Access Compliance Report

Public Rights-of-Way

(Curb Ramps)

Intersection ID: 10025341	Main Street: E_7TH_ST	Cross Street: N/A	Location: S
ADA ID: 6EDBDFB30ADA	Ramp Type: Perp	Initial Pass/Fail: Pass	Overall Compliance: No
		Severity Score: 0	
Codes/Mitigation Info/Possible Solution		Field Measurements/Component Compliance

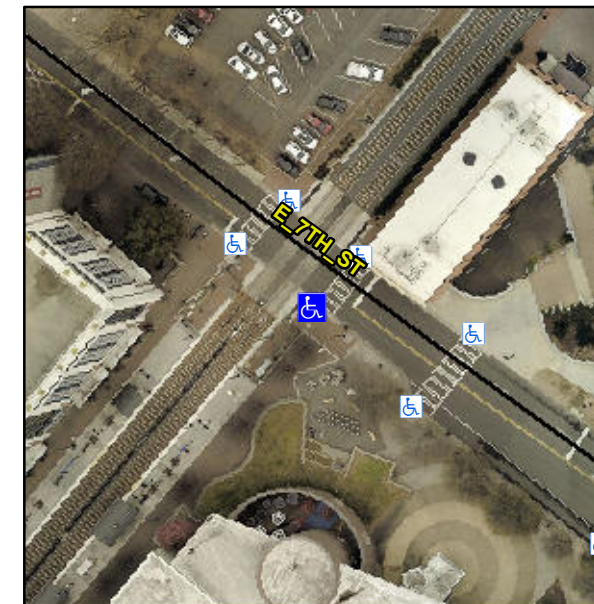
Not Found, R304.2.2-Perp, R304.3.2-Para

Compliance	Description	Data	Compliance	Description	Data
N/A	Ramp Length (in)	48.0	Yes	Ramp Slope (%)	5.2
Yes	Ramp Width (in)	48.0	Yes	Ramp XSlope (%)	0.5
N/A	Flare Type LT	Sloped	N/A	Flare Type RT	N/A
N/A	Flare Slope LT (%)	5.0	Yes	Flare Slope RT (%)	4.6
N/A	Flare Traversable LT?	Yes	N/A	Flare Traversable RT?	Yes
Yes	Landing Length (in)	48.0	Yes	DWS Provided?	Yes
Yes	Landing Width (in)	48.0	Yes	DWS Contrast?	Yes
No	Landing Slope (%)	3.3	Yes	DWS Length (in)	24.0
Yes	Landing X Slope (%)	0.4	Yes	DWS Full Width?	Yes
N/A	Landing Curb? (Y/N)	No	Yes	DWS Offset (in)	0.0
N/A	Shared Landing?	No			
Yes	Gutter Ponding?	No	Yes	Gutter Slope (%)	1.5
Yes	Gutter Lip Ht (in)	0.0	Yes	Gutter X Slope (%)	0.8
N/A	Painted X Walk1?	Yes	N/A	Painted X Walk2?	N/A
	X Walk 1 Direction	To NE		X Walk 2 Direction	N/A
N/A	X Walk 1 Width (in)	111.0	N/A	X Walk 2 Width (in)	N/A
	X Walk 1 Slope (%)	1.1		X Walk 2 Slope (%)	N/A
	X Walk 1 X Slope (%)	0.6		X Walk 2 X Slope (%)	N/A

Yes	Ramp inside XWalk1?	Yes	N/A	Ramp inside XWalk2?	N/A
	Road Slope (%)	N/A	N/A	Clear Space?	Yes
	Road X Slope (%)	N/A	N/A	Clear Space to XWalk (in)	N/A
Yes	Any Obstructions?	No	Yes	Storm Grate/Utility Hazard?	No
	Obstruction Type			Storm Grate/Utility Type	
		N/A			N/A
			Yes	Surface Condition? (G/P)	Good

Remove & Replace Entire Ramp.
